Planning Commission MEETING AGENDA

Easton Staff Development Review Comment Responses

Project: Port Street Commons
ATTN: Joe Mayer

Mr. Mayer,
Rauch inc. has reviewed comments received August 26th, 2022 and offers the following responses to the Easton Town Engineer, and Town of Easton Planning and Zoning:

A-101

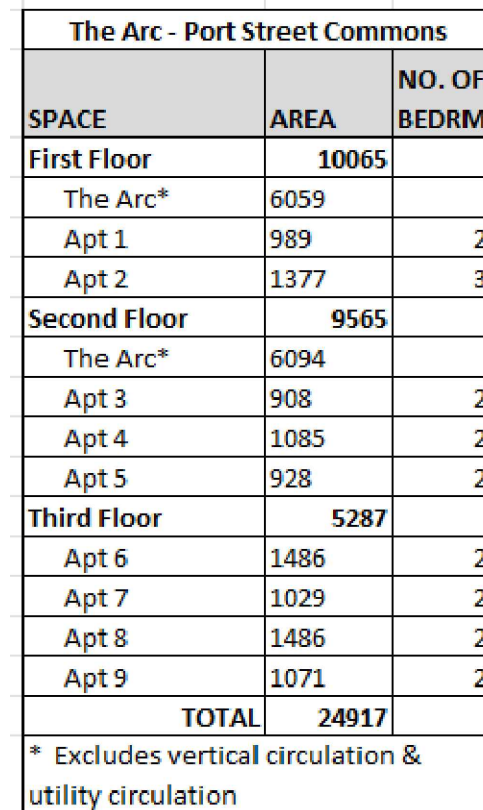
secondary front and or side facade." Based on the concept design, it is clear that the facade facing the stormwater area is different from the front facade and does not include the necessary architectural features for a three-story building.

- **Building has been updated accordingly.**
5. Per MXW 28-312.4.3 (C) "Solid walls shall not exceed 20 feet in length" please verify that the large wall on the south elevation does not exceed 20 feet in length.
 - **This has been revised.**
 6. Site Plan approval is contingent on the Town Council approving the requested Amendments to the Zoning Ordinance.
 - **Noted.**
 7. Determine Fire Lane for the building.
 - **Fire lane has been depicted on sheet C-101.**
 8. Avoid Forest Conservation Easements within the Delmarva Power & Light Company Easement. Has off-site location been determined for Afforestation?
 - **All afforestation will be paid fee-in-lieu and provided offsite.**

PORT STREET COMMONS

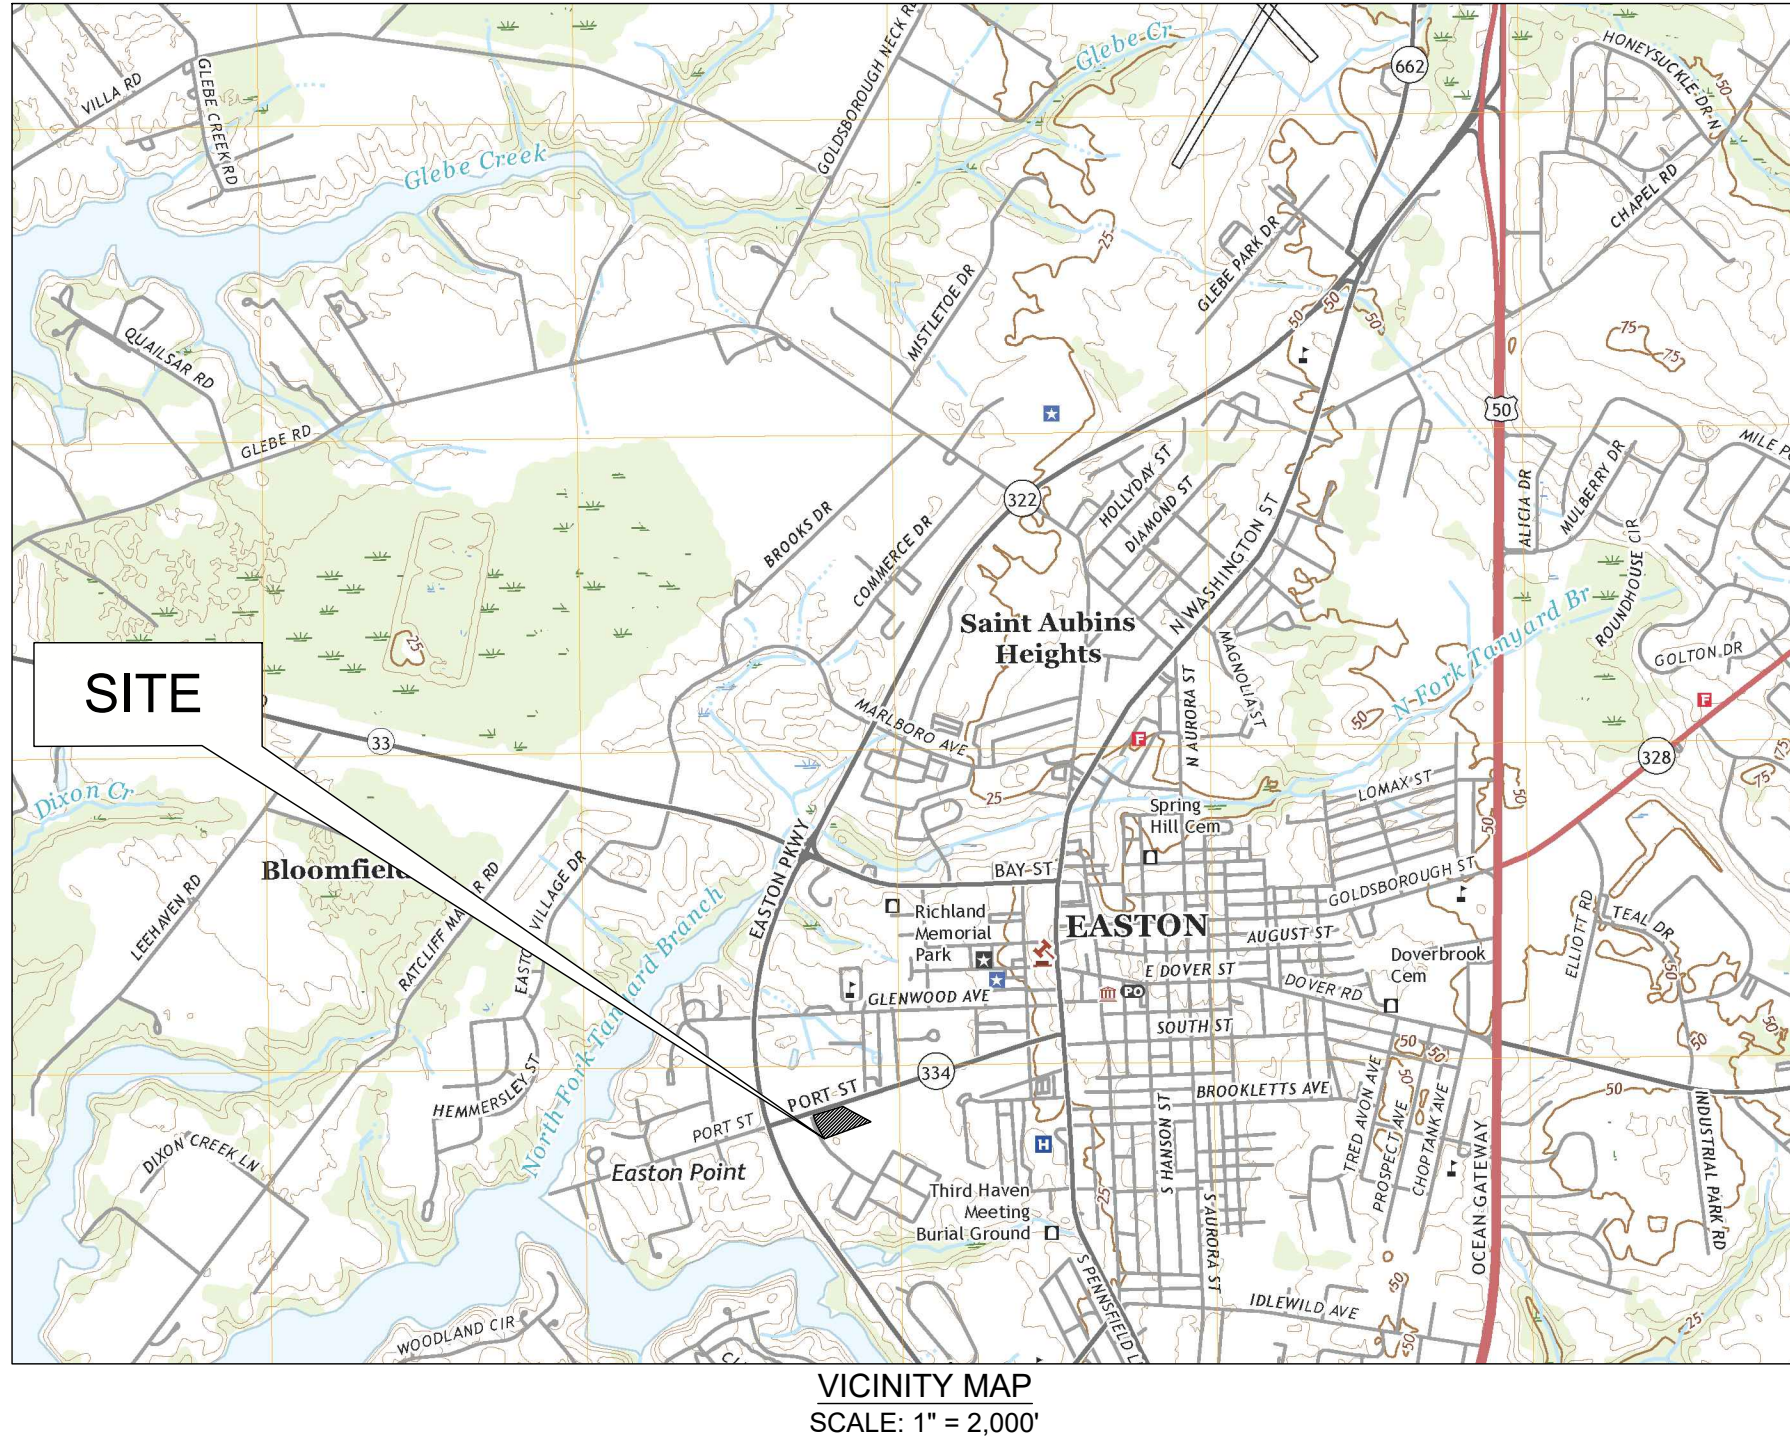
2. Provide a Quality Management summary table indicating ESD Volume Required and Provided (for each Study Point) on the plans (possibly Sheet G-100) and in the Stormwater Management Report.

- **Table has been added to sheet G-100.**

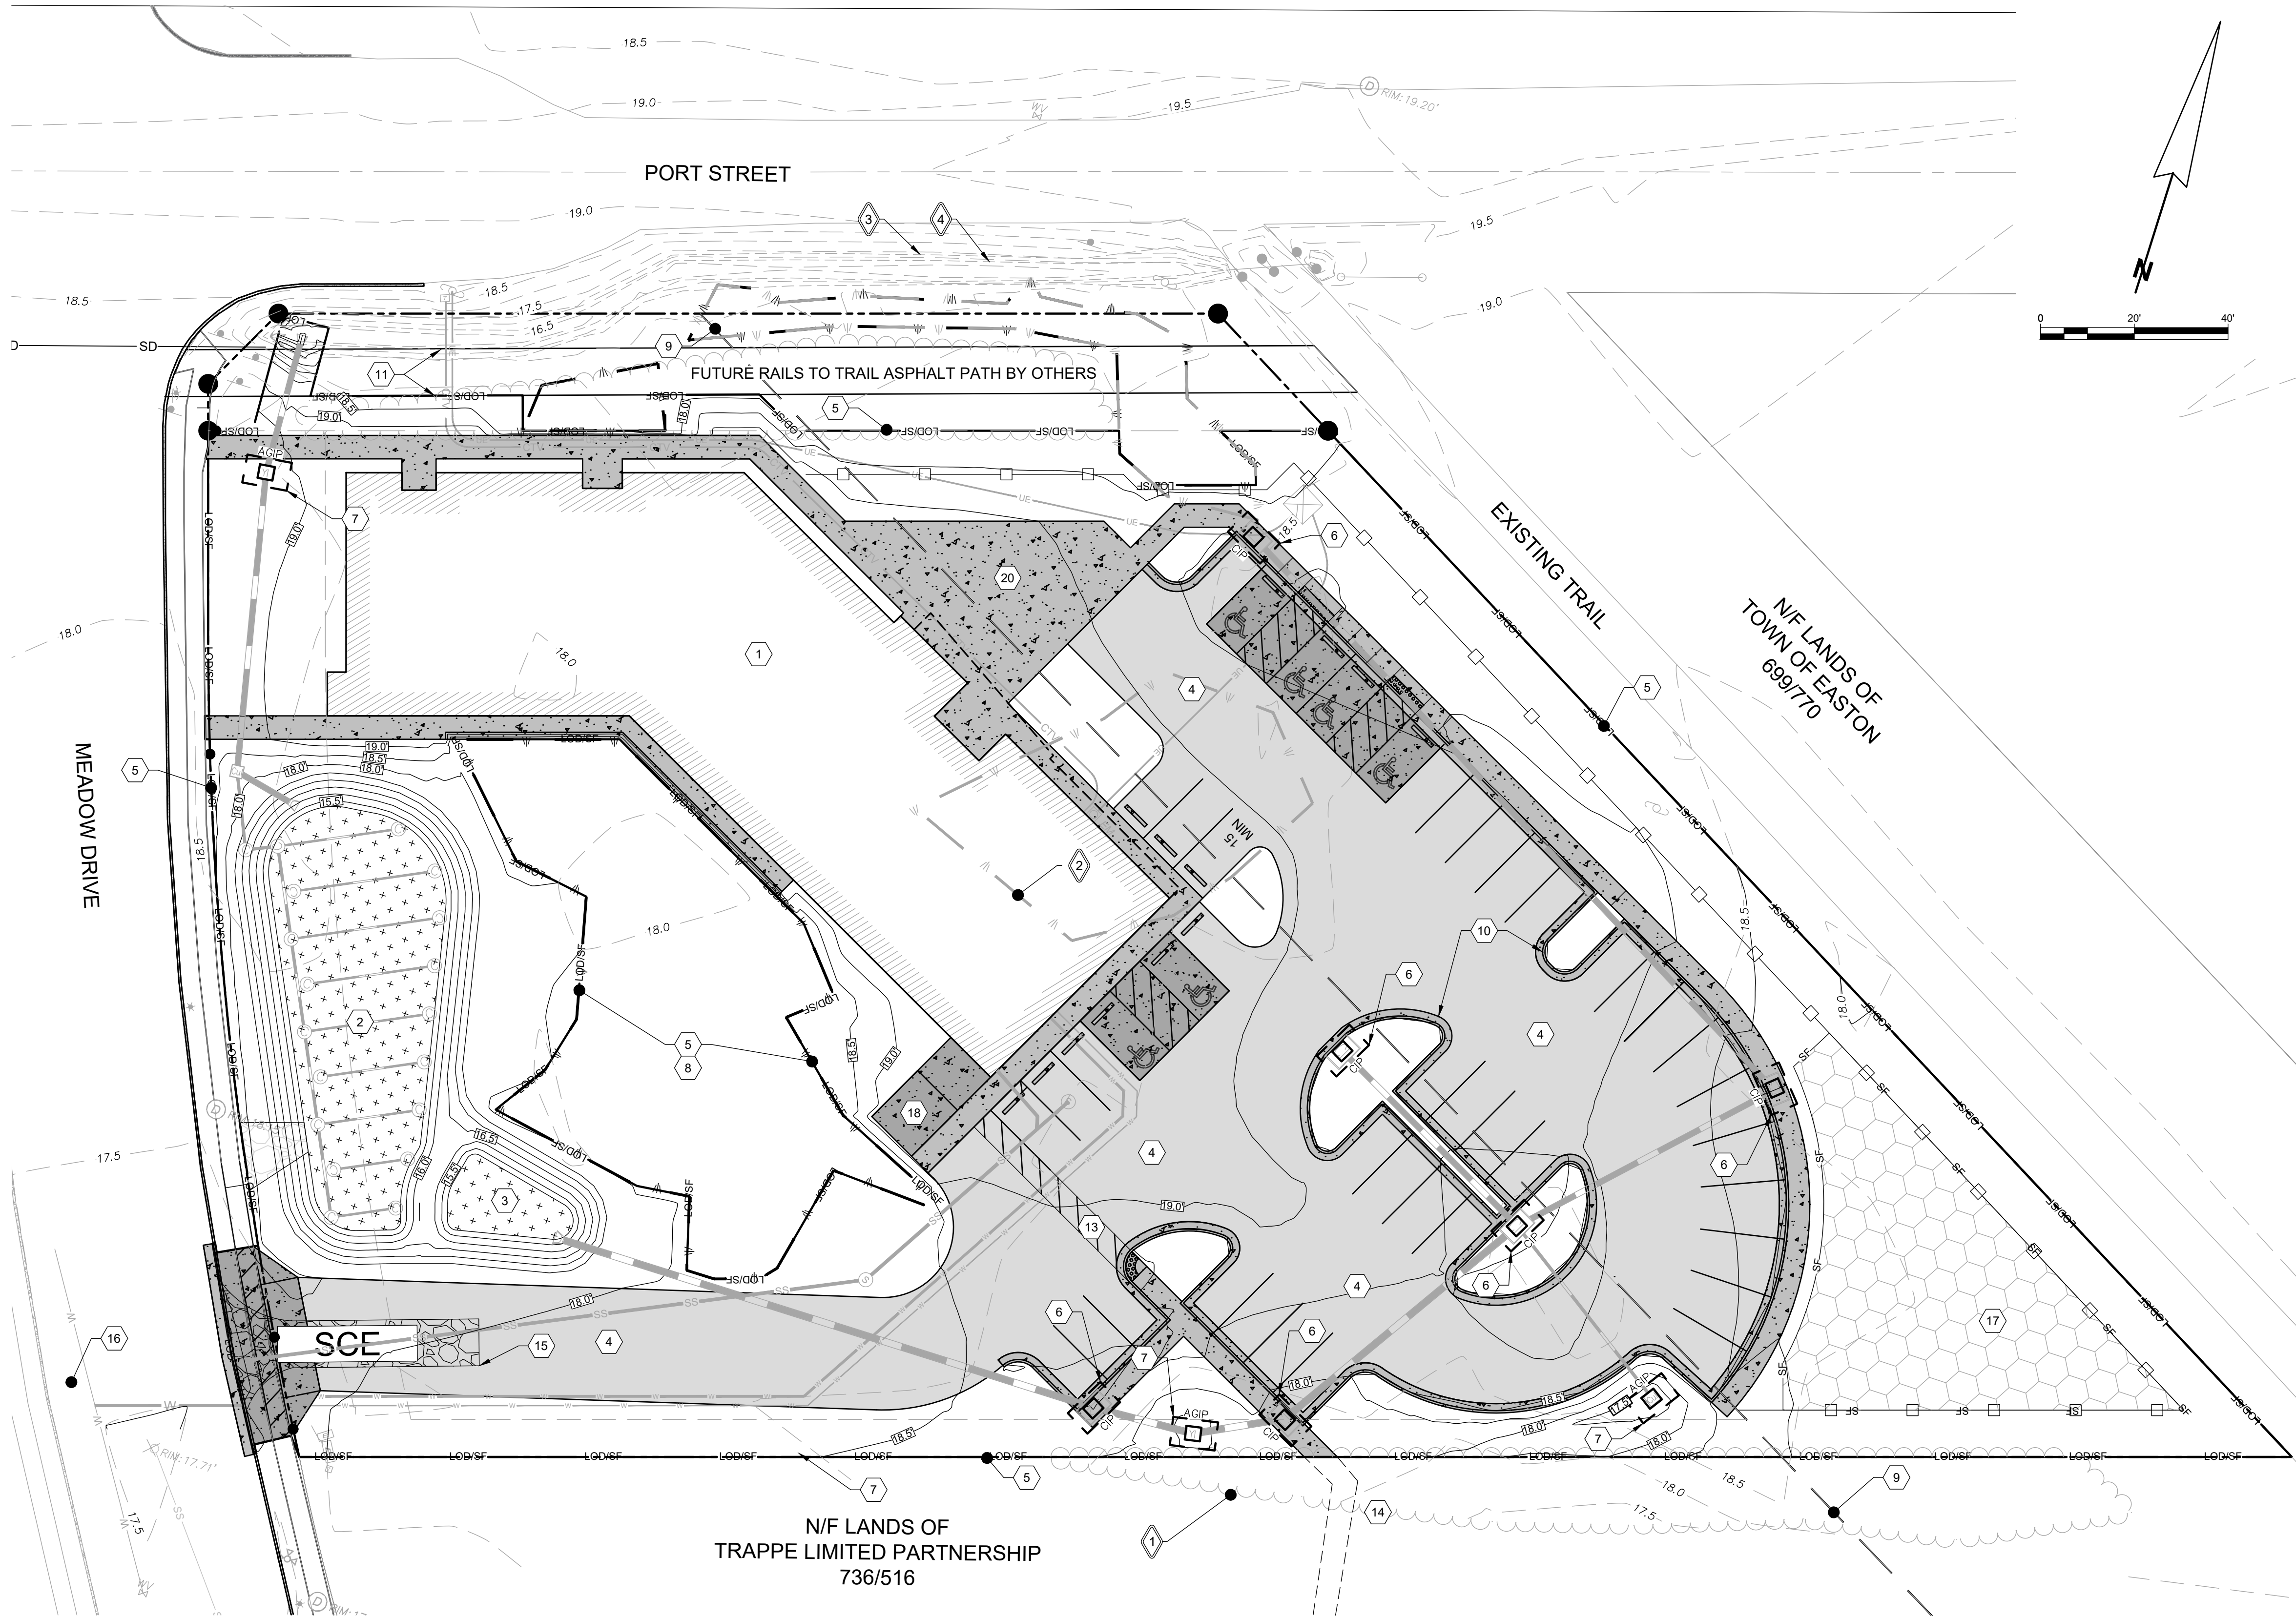
1. **SHEET C-101** - Consider using a concrete entrance at Meadow Gate Drive (TOE-R-4.02). This helps with grade control for the ADA

compliant crosswalk and eliminates the need for ADA ramps as the sidewalk connects to the entrance.

- **Entrance has been updated accordingly. Detail has been added to sheet C-305.01.**
